North Liberty Planning Commission
Tuesday, October 6, 2020, 6:30 PM

To **City of North Liberty Planning Commission**
From **Ryan Rusnak, AICP**
Date **October 2, 2020**
Re **Request of Tyler and Jennifer Doran to approve a Preliminary Plat for a two lot subdivision at 1475 South Jones Boulevard.**

To **City of North Liberty Planning Commission**
From **Ryan Rusnak, AICP**
Date **October 2, 2020**
Re **Request of Watts Group Development, Inc. for a zoning map amendment on 7.87 acres, more or less, from RM-8 Multi-Unit Residence District to RS-4 PAD Single-Unit Residence District Planned Area Development on property located at the southwest corner of Denison Avenue and Oak Terrace Avenue, being Lot 29 of The Preserve, Part One.**

DRAWINGS FOR PROPOSED IMPROVEMENTS
THE PRESERVE
LOT 29 PAD SITE PLAN
IN THE CITY OF NORTH LIBERTY, JOHNSON COUNTY, IOWA

SHEET NUMBER: C3.00

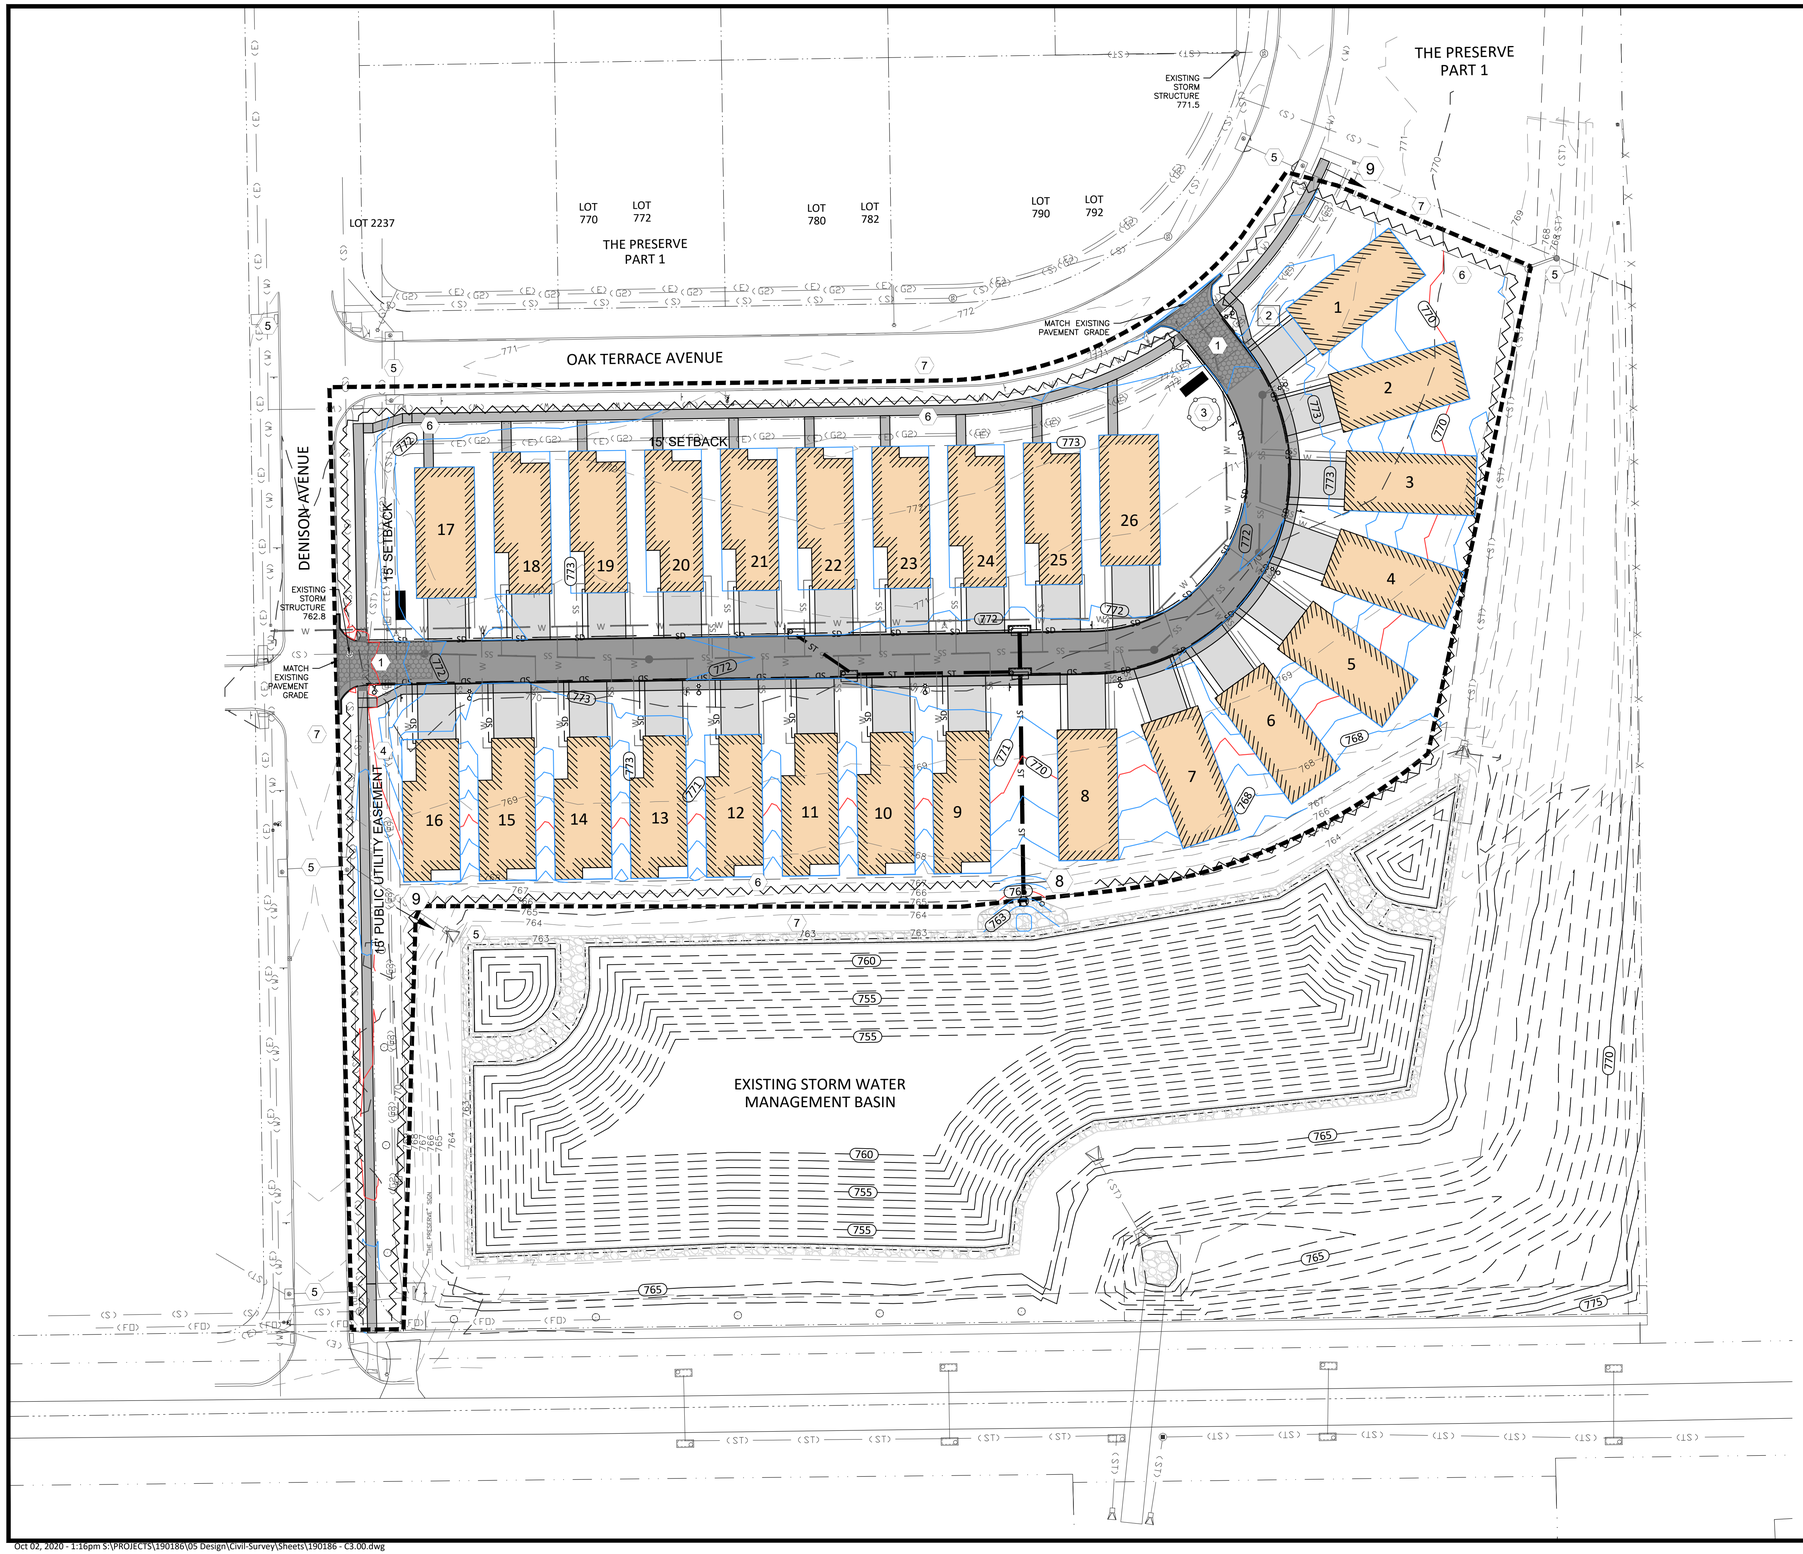
1. The plans be revised such that the top of foundation wall or window wells not be lower than the minimum low opening elevation; and
2. That the grade plan depict the design the overland drainageways through this lot for each location such that stormwater runoff street overflow will not encroach on unit 1 or unit 16;

8. That the plans be revised such that the top of foundation wall or window wells not be lower than the minimum low opening elevation; and
9. That applicant demonstrate the site plan's consistency with the City's post-construction storm water runoff control ordinance, as determined by the City Engineer, prior to City Council's consideration of the zoning map amendment.

SHEET NUMBER: L1.00

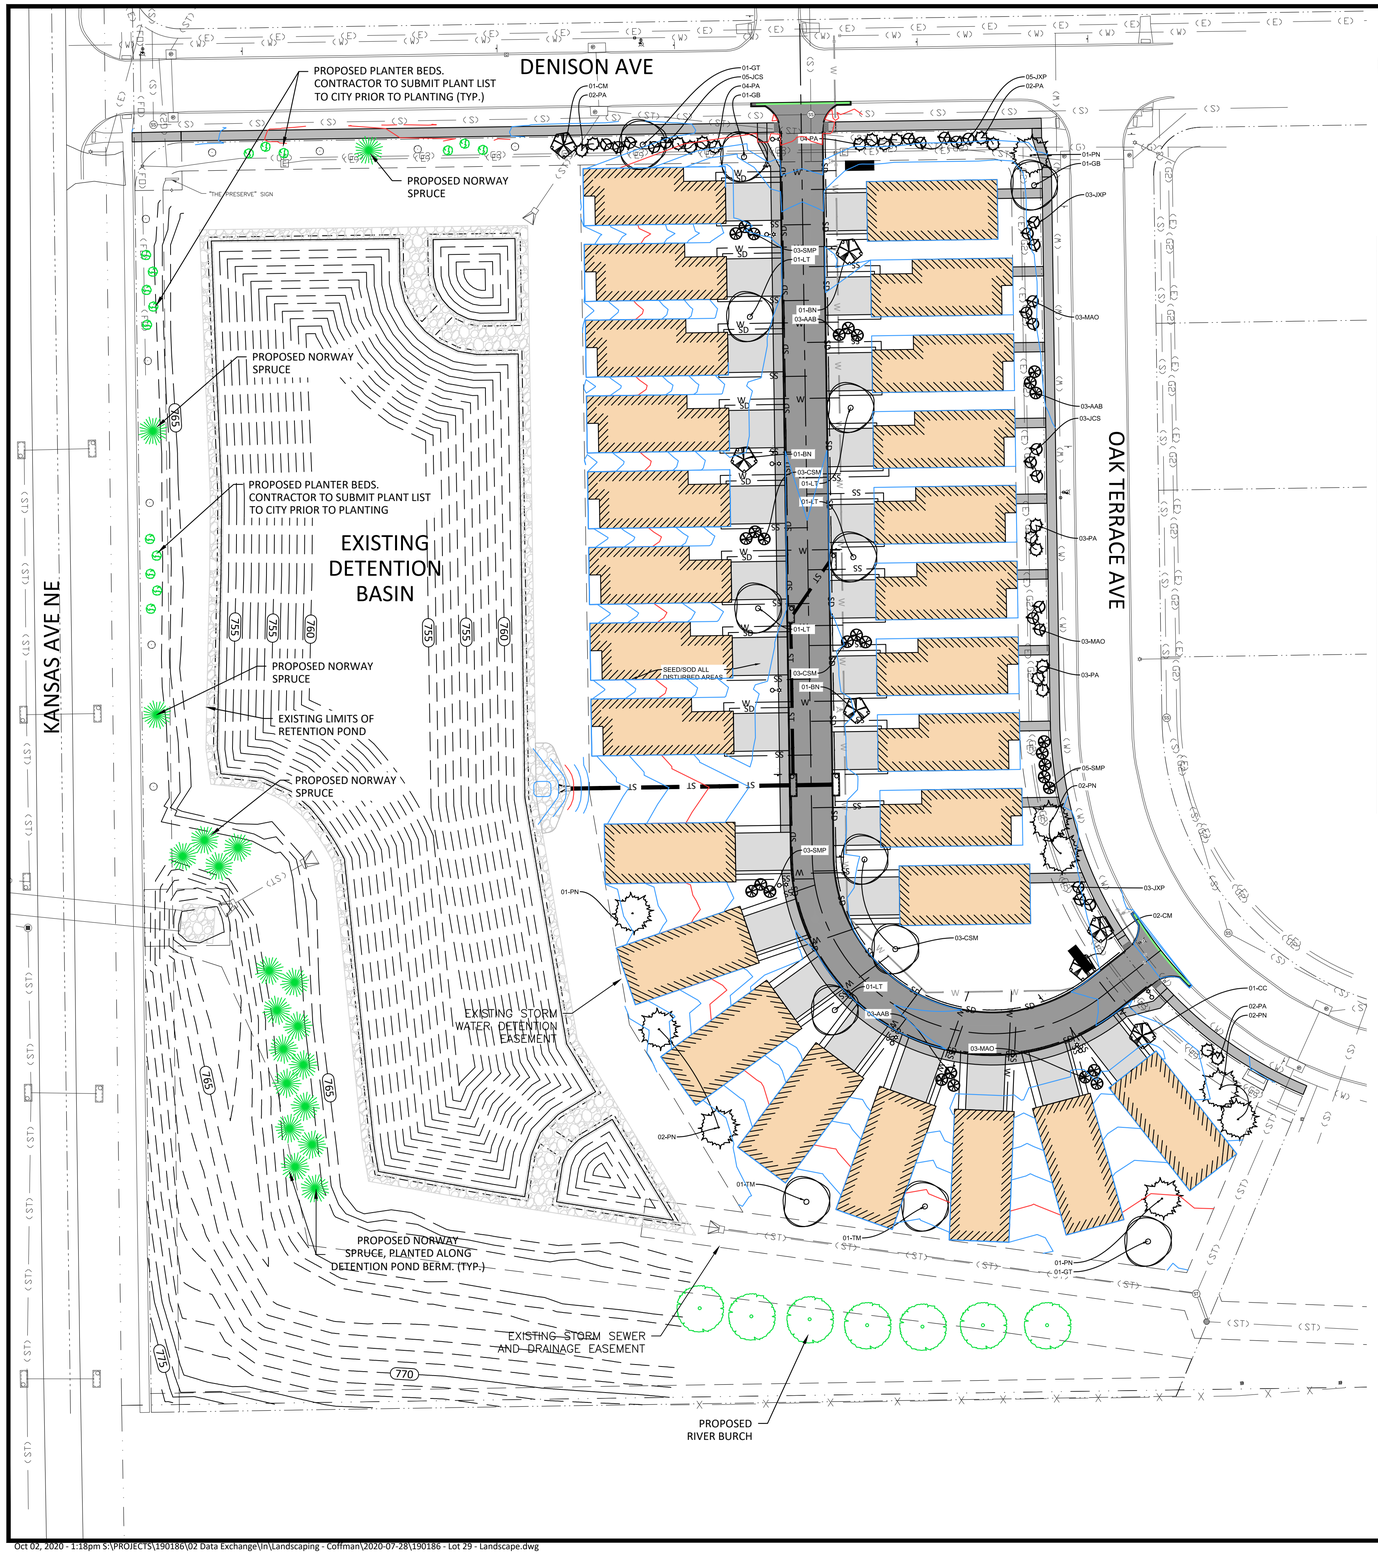
6. That the mailbox pad located at the southeast portion of the property be labeled on the site plan;
7. That the landscaping to revised to adhere to the visual corner clearance at the intersection of streets;
